CLONBURRIS T2

ARCHITECTS
FURTHER INFORMATION
RESPONSE

Planning Reg Ref: SDZ22A/0018

July 2023

Item no. 1 (d)

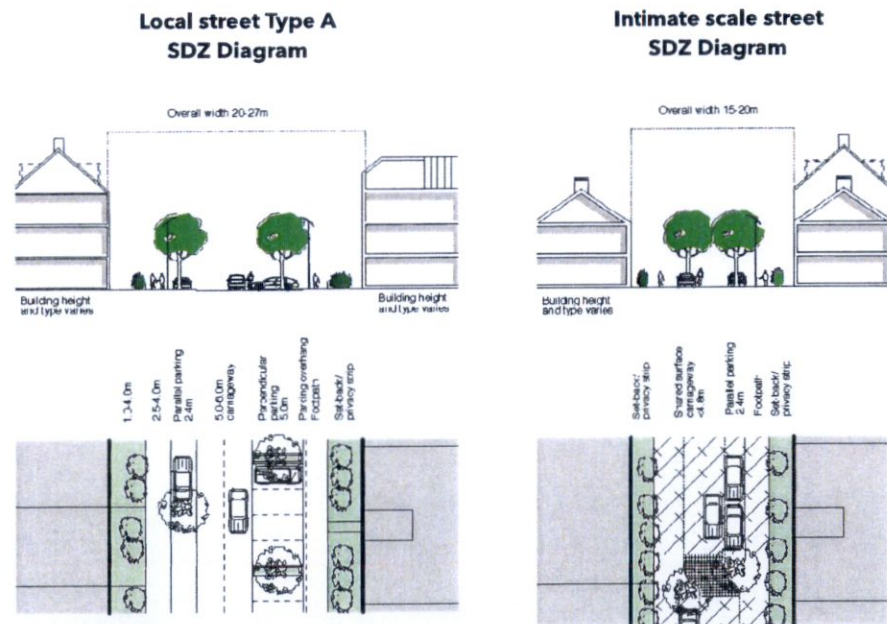
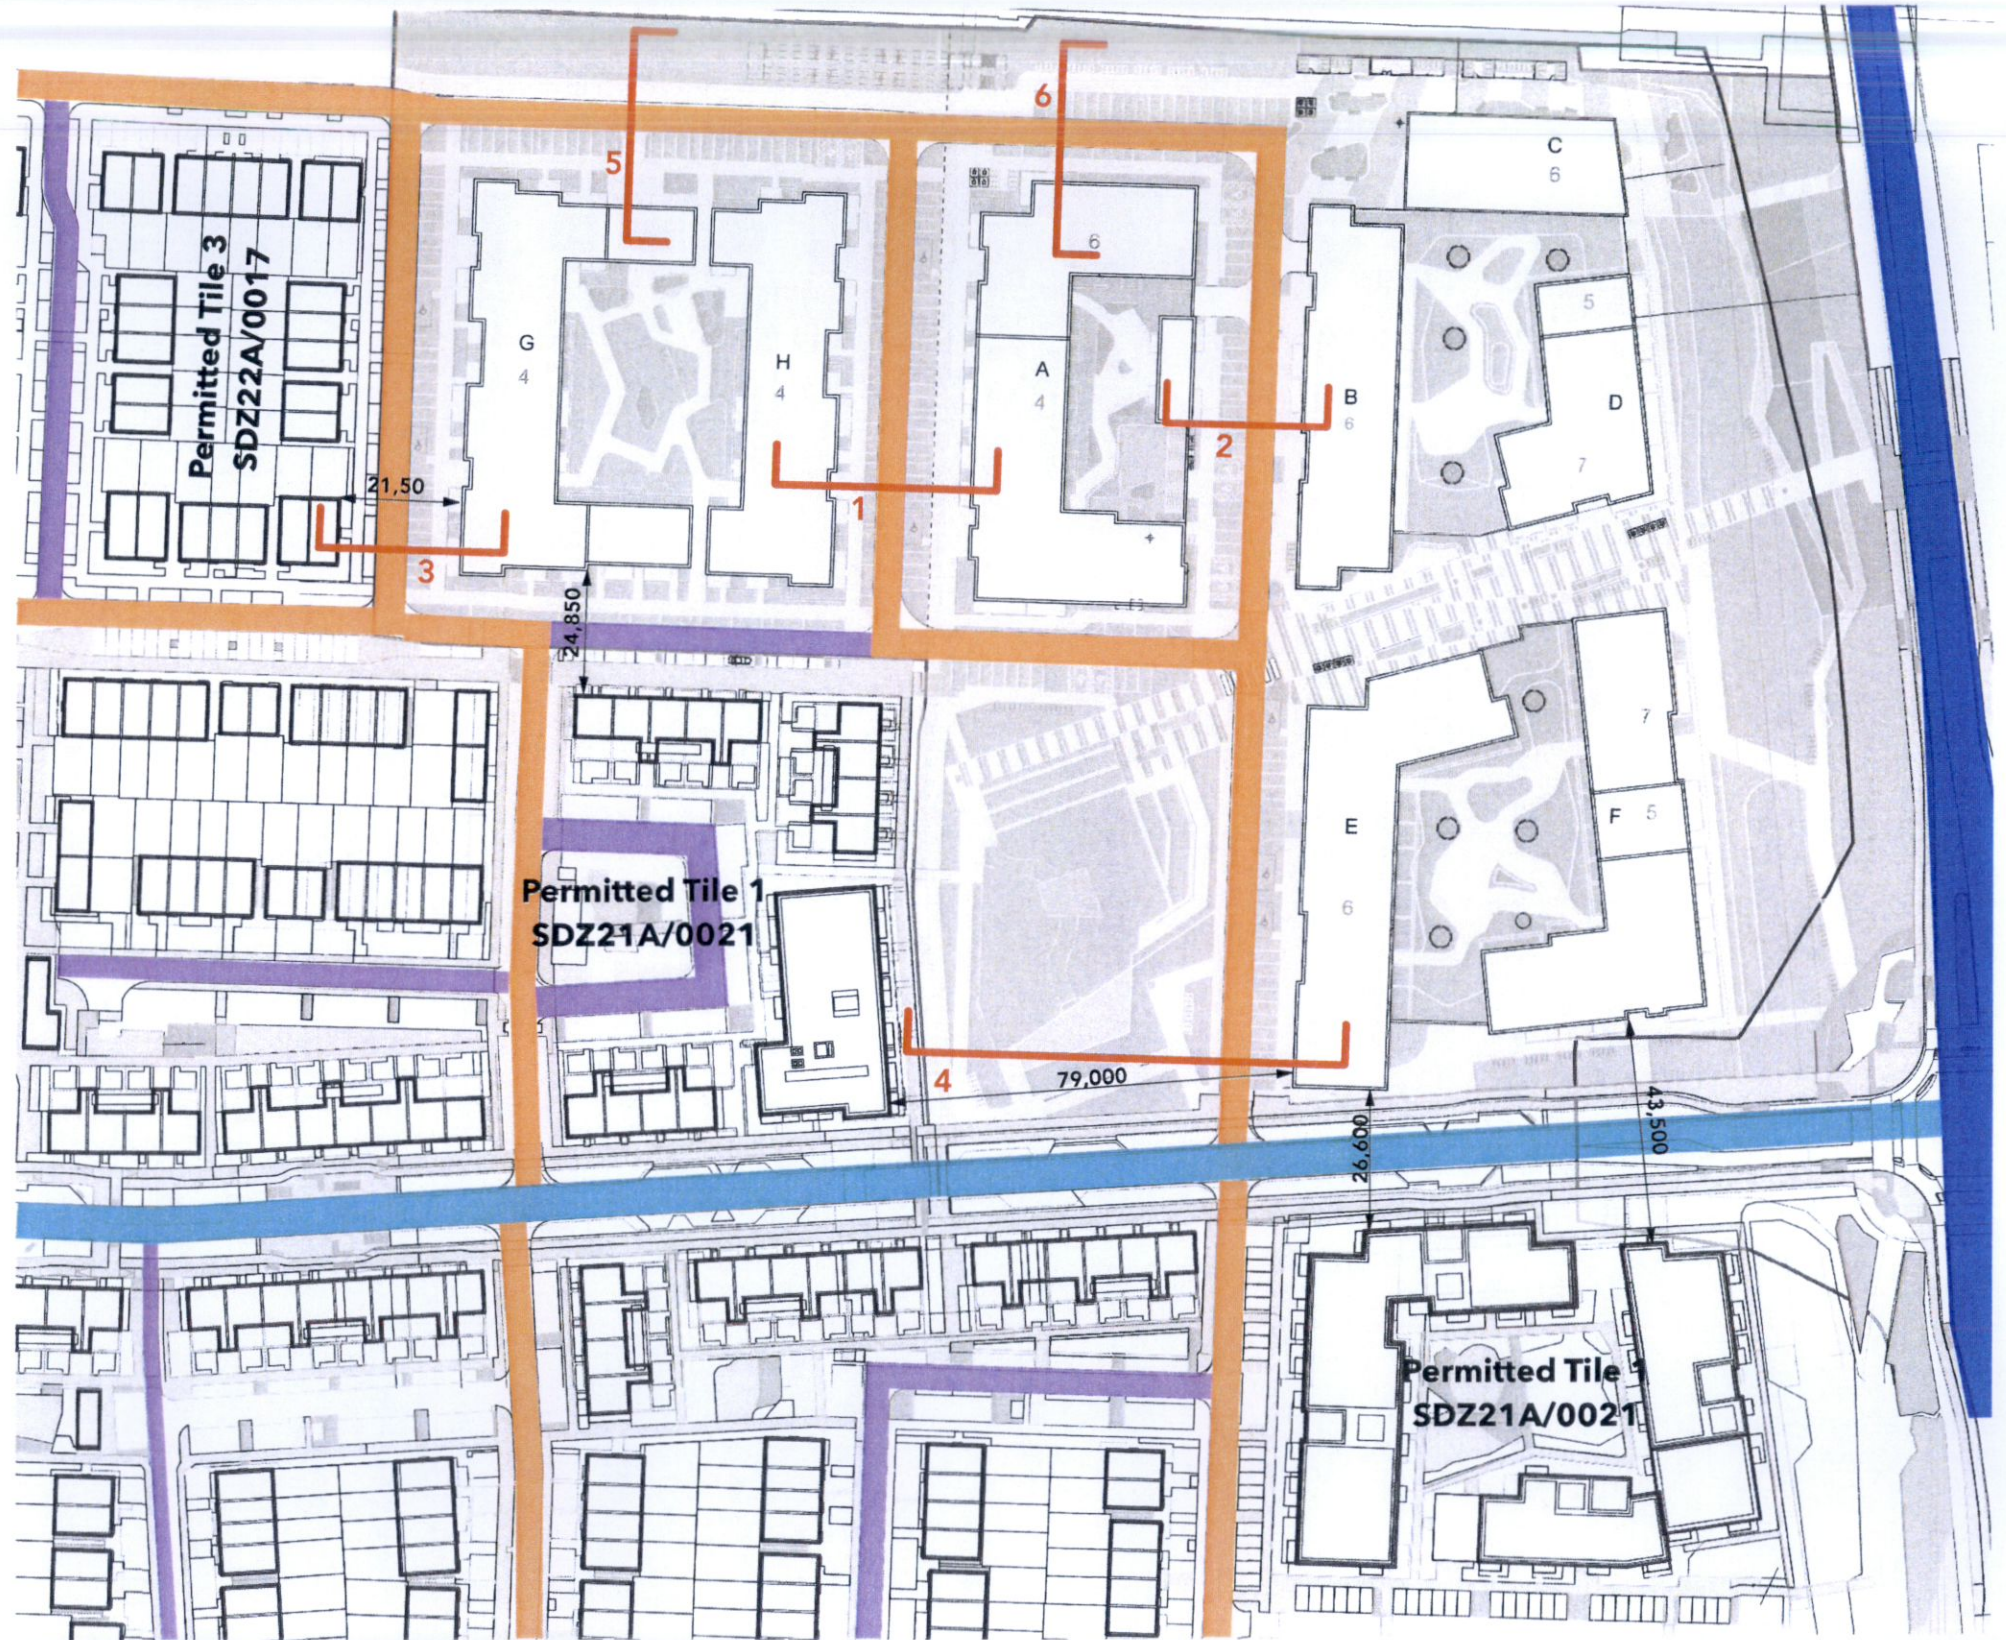
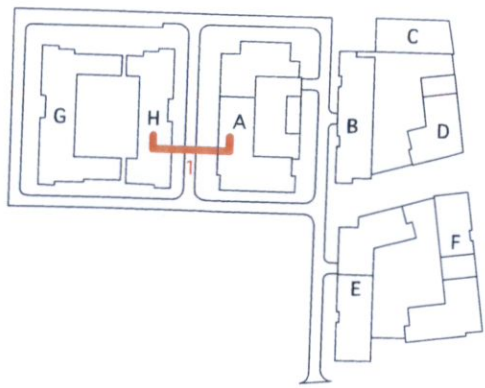
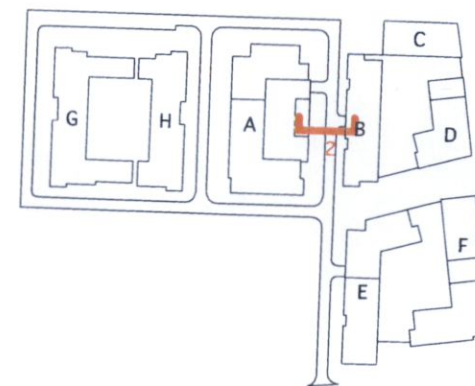
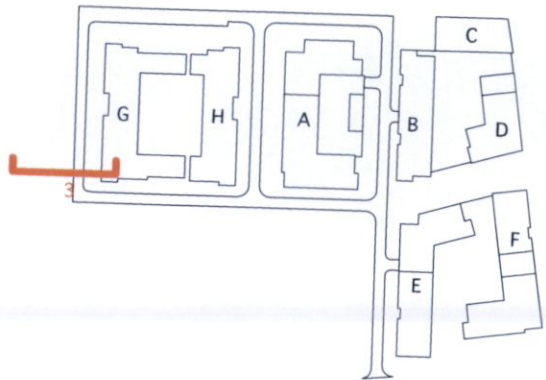
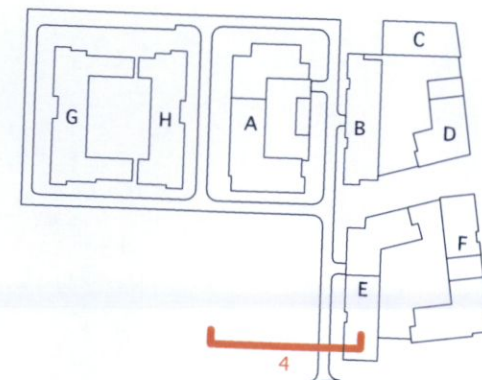
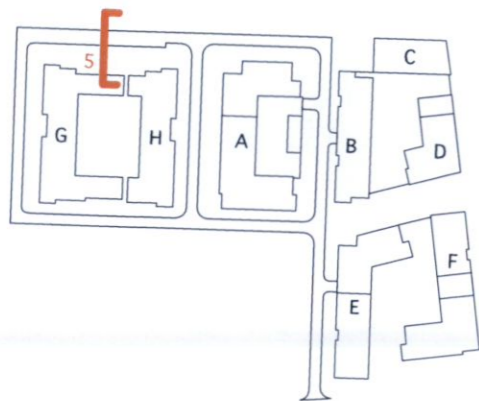
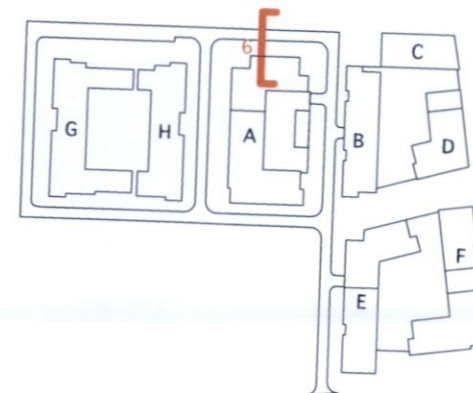
d. Street design: The applicant is requested to provide a clear layout plan indicating: - The road typology - Width between building frontages (including areas with planning permission or under consideration applications) - Carriageway width - Footpath width - Privacy strip width (if present) - Location of street trees. Cross sections should also be provided where relevant.

In response to Item 1d, the site Layout Plan has been revised to include additional dimensions. The road typology is shown on the included diagram in line with the requirements of the SDZ Planning Scheme and also on a separate Movement Strategy drawing prepared by DBFL consulting engineers. The following pages include a series of 3d street cross sections with dimensions of each element to help demonstrate adherence to the requirements of the SDZ Planning Scheme.

Item no. 2 (a)

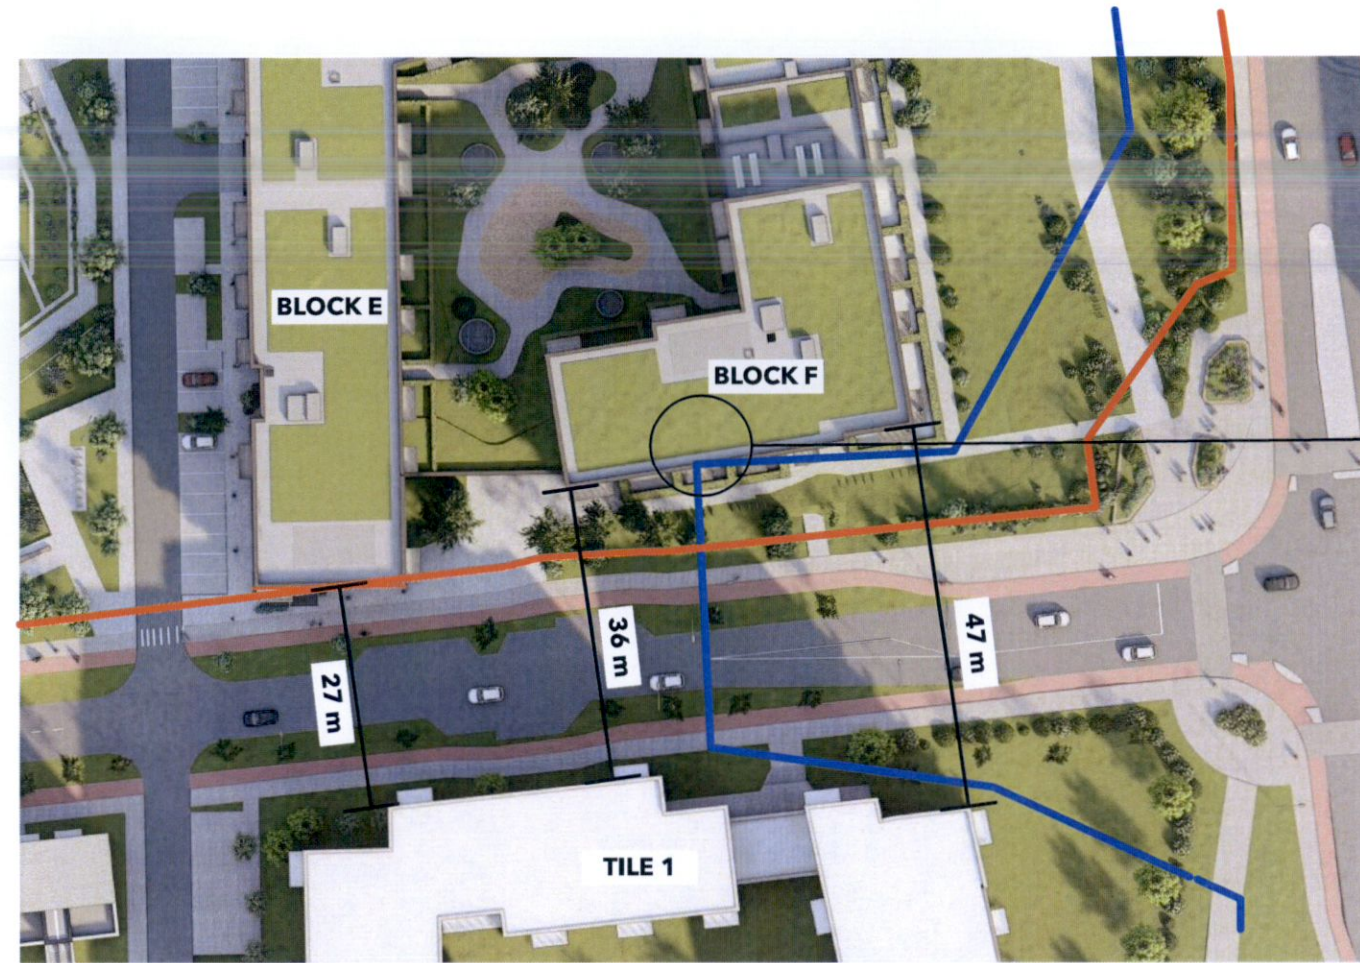
a. It is noted that the scheme envisages a perimeter block to the south, where blocks E and F are located. It is noted that there is a break in this frontage at present and also that Block F is set off the southern link road. There do not appear to be any physical constraints to providing a strong frontage at this location. The applicant is requested to redesign this area to provide building frontage to the link street.

Block E&F are designed as a perimeter block, fully enclosed at street level, with a narrow break on the south elevation above podium level to allow daylight/sunlight to the landscaped internal courtyard and improve the dual aspect ratio to the apartments in this location.

The southern building line of Block E and F is tight to the Applicant's ownership line and mirrors the profile of Block A in permitted Tile 1, which also graduates outwards to the east to respect the ownership line. Both buildings create an urban entrance gateway to Clonburriss from Fonhill Road and the distance between the blocks is an appropriately scaled urban entrance to this new neighbourhood. From an urban design perspective the mirrored layout is preferred on either side of the entrance.

The apartment buildings on either side of the Link Street move closer together tracking the land ownership line to establish a building line along this street. Additional own door residential units have been introduced to the ground floor of Block F to bring added activity at street level. Well designed landscaping completes a strong and attractive frontage from the linear park on the east to the urban square to the west of Blocks E & F.

BLOCK A ADDITIONAL UNITS:

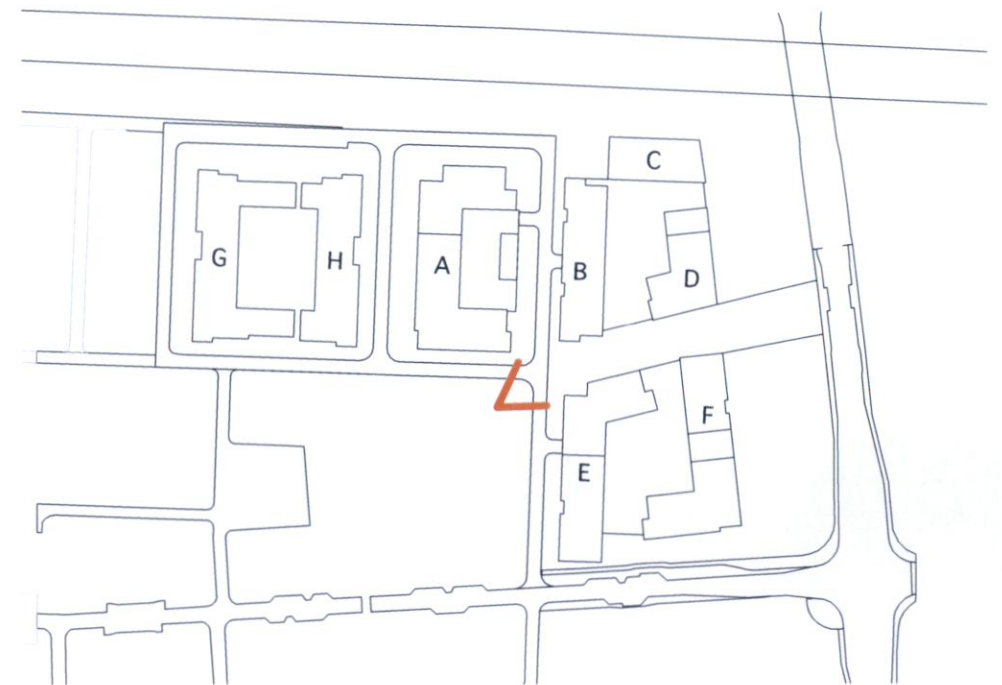
e. The applicant is requested to give further consideration to the design of the ground floors of Blocks B, D, E and F and articulate the ground floor main façade, including in terms of shopfront design where areas of retail are proposed and articulation of the main entrances

In response to this request an additional eleven ground floor apartment units have been added throughout Blocks A, B, D and F. There is no opportunity to add units to Block E which has extensive retail frontage at ground floor level. All these apartments have own door access to the outside to enhance the occupant's interface with the surrounding streets and landscaped areas.

NEW PAVILION BLOCK TO EAST EDGE OF BLOCK A
CREATES ADDITIONAL 2NO OWN DOOR
RESIDENTIAL UNITS TO THE STREET WHILE
MAINTAINING SUNLIGHT/DAYLIGHT TO LANDSCAPED
PODIUM ABOVE

Item no. 4 (a)

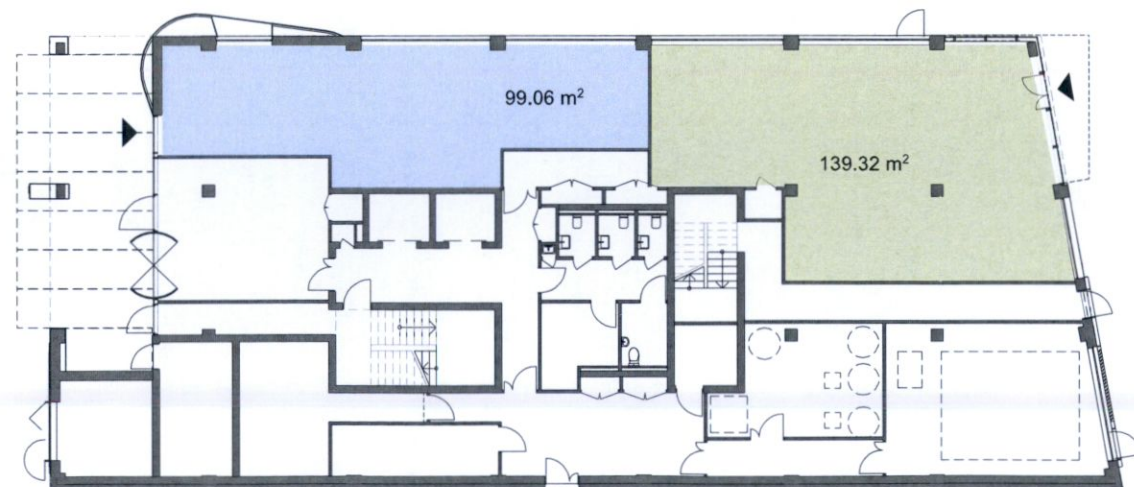
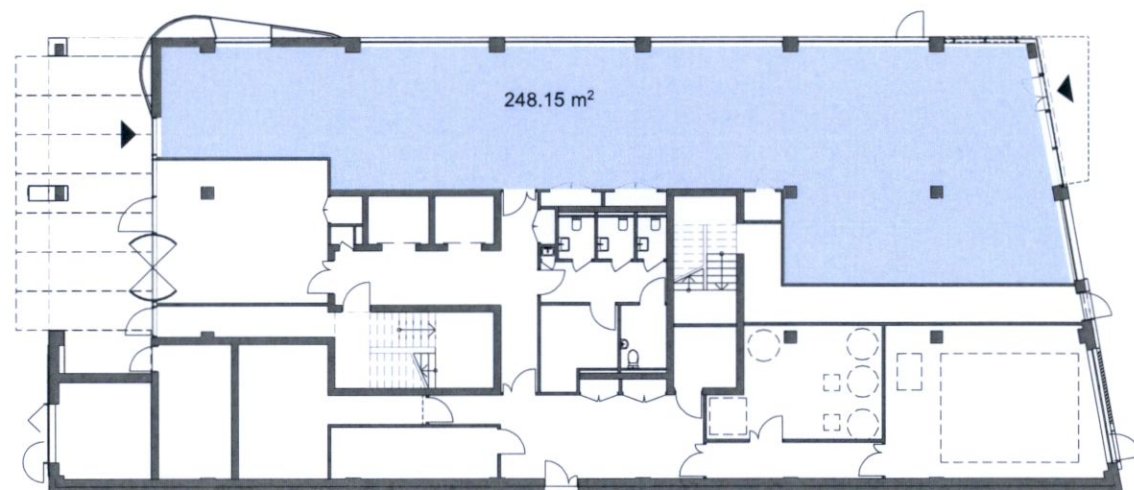
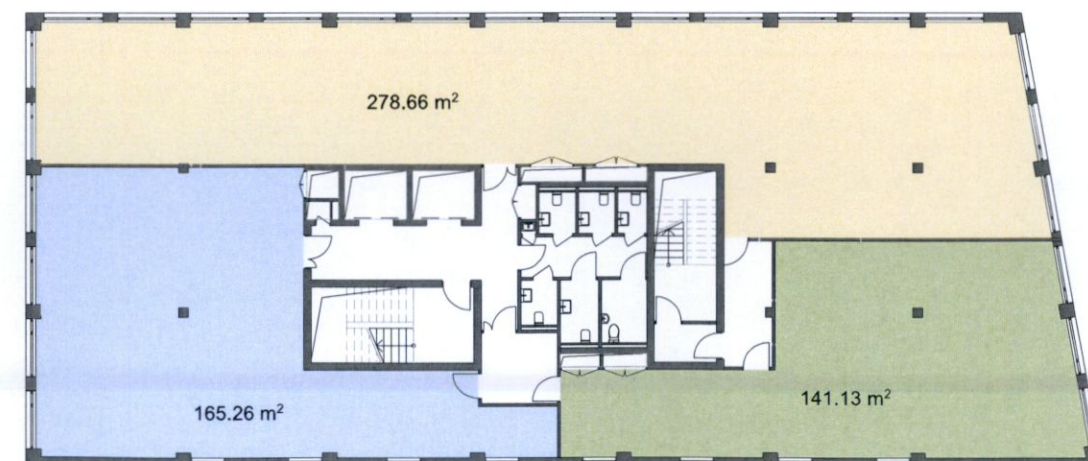
In accordance with Section 2.6.3 As a minimum, 10% of the employment floorspace provided in the Urban Centres shall be in the form of small-medium sized units/ incubation units of between 100 – 300sq.m. It is noted that the commercial building generally provides large open plan office space in excess of this. The applicant is requested to indicate that 10% of the proposed floorspace meets the above requirement.

The Employment Building has been designed for flexibility in subdivision of all floor plates to provide units of between 100-300 sqm above the 10% provision. This allows the full building to meet the potential needs of future end users. The plan indicates how this can be achieved.

Item no. 6 (a)

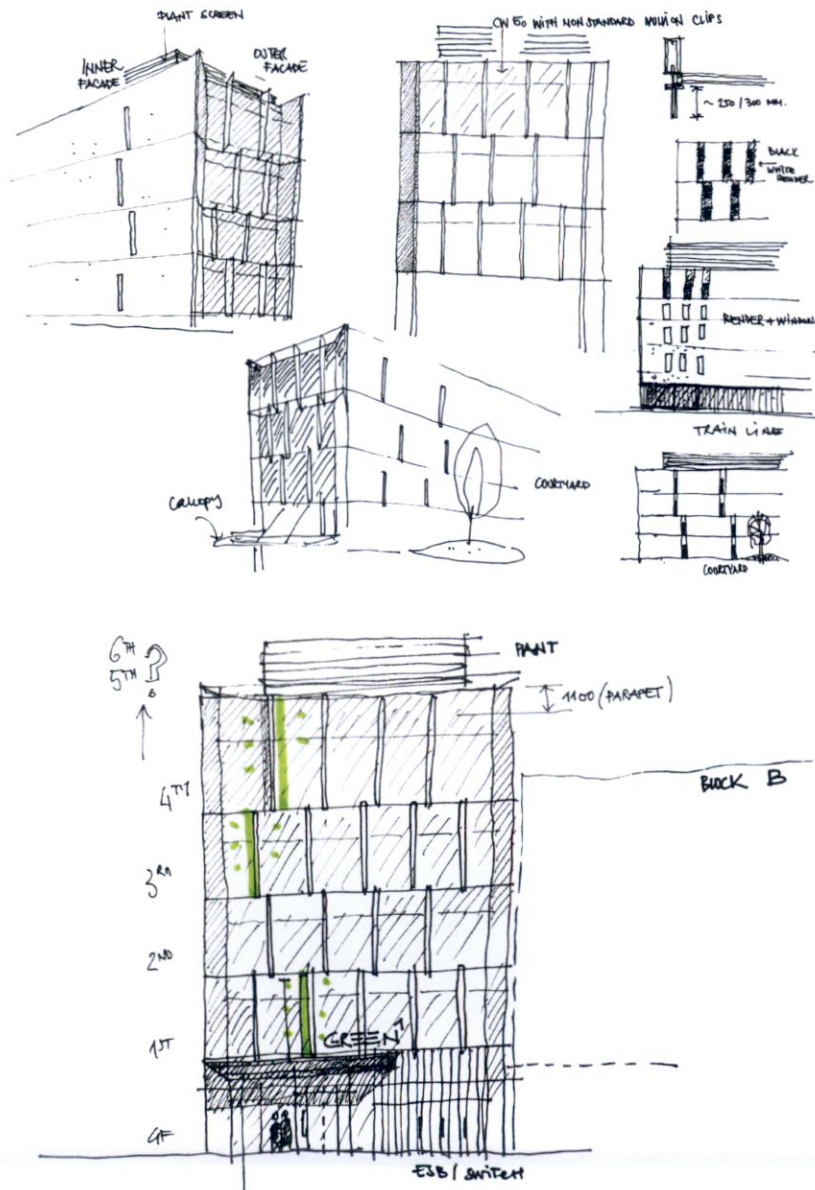
a. The applicant is requested to detail the design evolution of the landmark building and how the current proposal was deemed the most acceptable design. The applicant should set out details of any design competitions.

The design process to select the best and most appropriate design of the Landmark Building was carried out by a group of designers from ALTU architects. Internal workshops and design reviews were organized before presenting various options to the Client and Planning Authority.

Working in a BIM environment various options were tested in 3D and numerous CGIs and virtual massing models were created, to study how the proposed building will work in the wider context. Initial proposals with smaller windows, different proportions and more formal articulation of the facade were abandoned as not meeting Landmark building criteria.
